From: Fedotov, Alexei
Sent: Friday, April 03, 2015 2:22 PM
Subject: RE: LEReC Cooling Section Component Design Meeting 4 - 2 - 15

LEReC Cooling Section Design Room

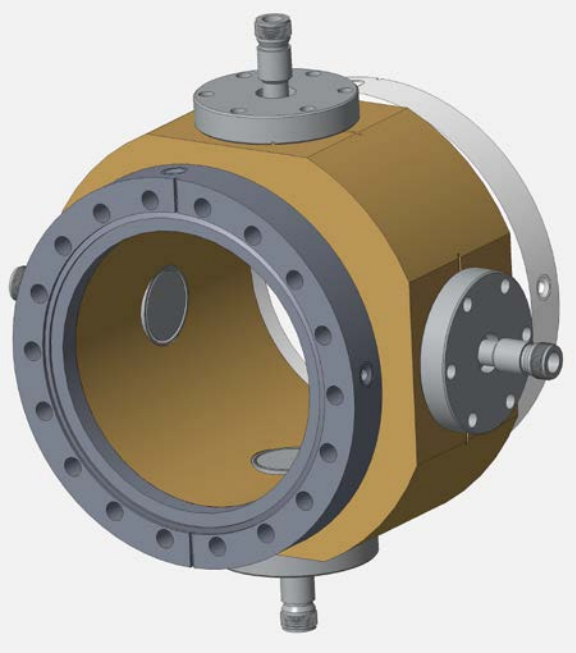
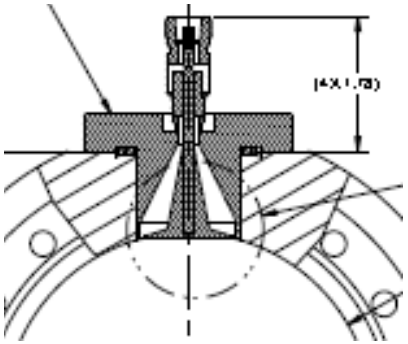
2.38” ID gives sufficient margin for the merger section (from one 20 deg. dipole to another). It is sufficient for beam transport line of LEReC Phase-I as well.

However, to take into account LEReC Phase-II with higher charges, the area from the DC gun to the SRF booster and then additional area where for Phase II zig-zag will be needed from the SRF booster to the SRF 5-cell cavity should be revisited when choosing appropriate vacuum chamber size.
